GE Appliances

Service Bulletin

**REFRIGERATOR-FREEZER
ICEMAKER EQUIPPED MODELS
NEW SINGLE WATER VALVE**

REF 11-00

NEW SINGLE WATER VALVE

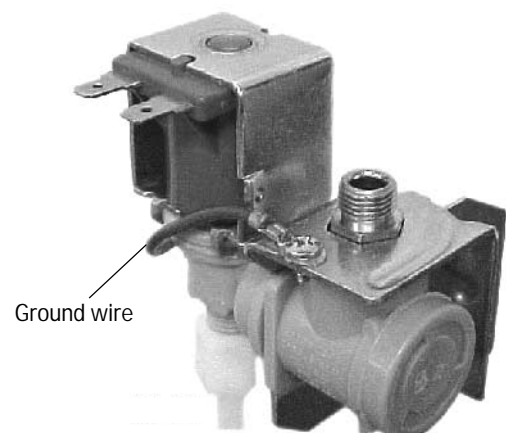
Beginning in late July 2000, all icemaker equipped refrigerator -freezer models will come with a slightly different single water valve.

The new single water valve will no longer have a ground wire installed. The bracket is now a one piece design, eliminating the need for the wire. The bracket material finish is also different. the new bracket uses a zinc galvanized coating instead of the yellow chromate coating. Valve operation, connection, etc. is unchanged.

There will be no part number change. The new valve is a direct replacement for the old valve. Consumer Service replacement parts, including the icemaker kits, will also carry this new valve.
